DEVELOPMENT APPLICATION ASSESSMENT REPORT

Application Number:	DA2022/0570
----------------------------	-------------

Responsible Officer:	Olivia Ramage
Land to be developed (Address):	Lot 61 DP 8871, 32 Ettalong Street WHEELER HEIGHTS NSW 2097
Proposed Development:	Alterations and additions to a dwelling house including a swimming pool
Zoning:	Warringah LEP2011 - Land zoned R2 Low Density Residential
Development Permissible:	Yes
Existing Use Rights:	No
Consent Authority:	Northern Beaches Council
Land and Environment Court Action:	No
Owner:	Jason Stephen Cummings Verina Cummings
Applicant:	Jason Stephen Cummings

Figure 1 - Eastern Side Boundary Envelope

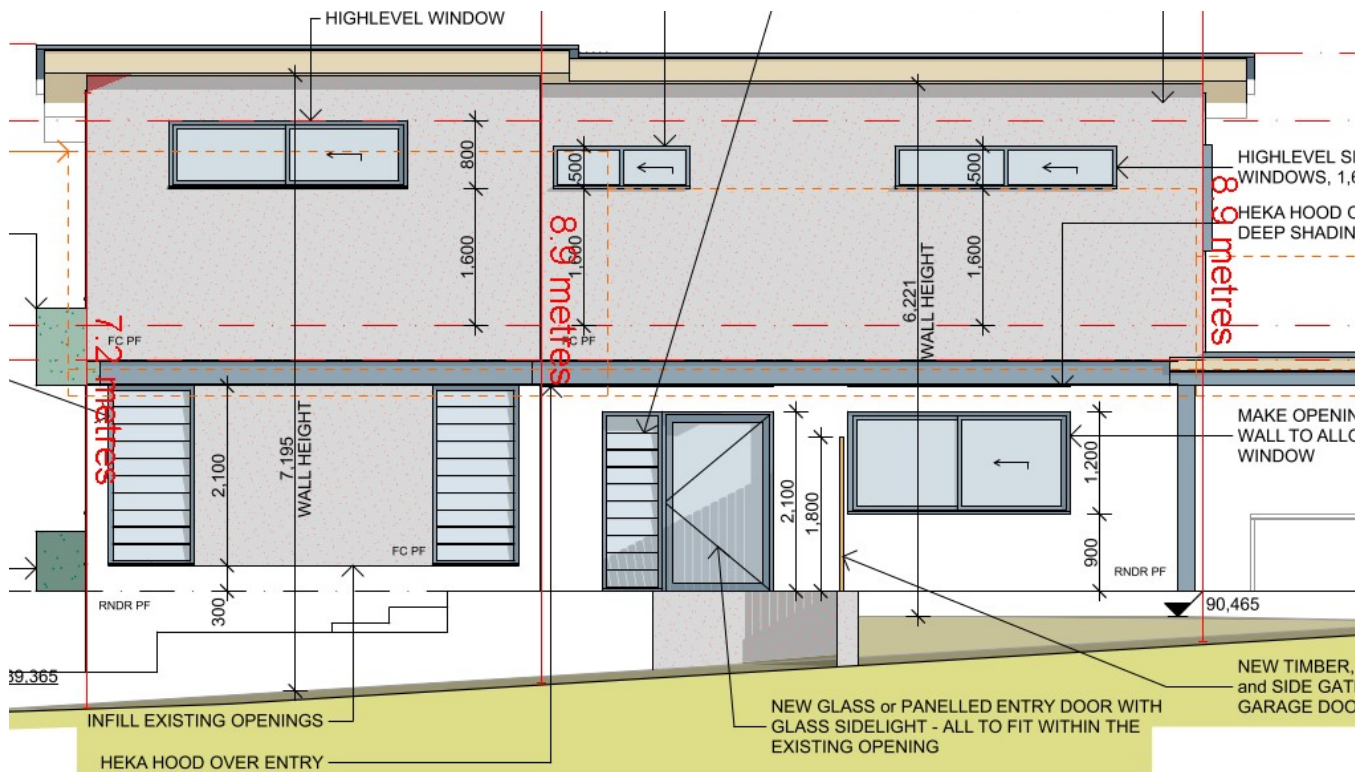
This control requires development to be sited within a building envelope determined by projecting planes at 45 degrees from a height of 4m above ground level. The proposed development breaches the eastern and western side boundary envelopes. On the eastern elevation, there is an encroachment between nil and 0.2m for a length of 0.5m. On the western elevation, there is an encroachment between 1.3m and 1.9m for a length of 11.3m. The original proposal had a larger breach to the western side boundary envelope, and amended plans were requested to minimise the non-compliance. Amended plans were submitted which removed the timber privacy screen from the western side of the balcony, and the first floor has been stepped in a further 0.8m from the ground floor below.

The proposed first floor addition complies with the front, side and rear setback controls and does not exceed a maximum height of 8.5m. The bulk of the proposed development has been reduced through the addition of a balcony at the south western edge of the first floor. The western side of the whole first floor has been stepped in 0.8m further than the ground floor below to reduce the bulk of the addition. The visual impact of the proposed development has been minimised through the addition of a planter along the southern and western edge of the dwelling. This planter provides articulation and a separation element to help soften the development and ensure it does not become visually dominant. Additionally, the proposal retains substantial landscaping in compliance with the control which further reduces the visual dominance of the development. Evidently, the overall level of compliance and the design of the first floor ensure that the development does not become visually dominant by virtue of its height and bulk.
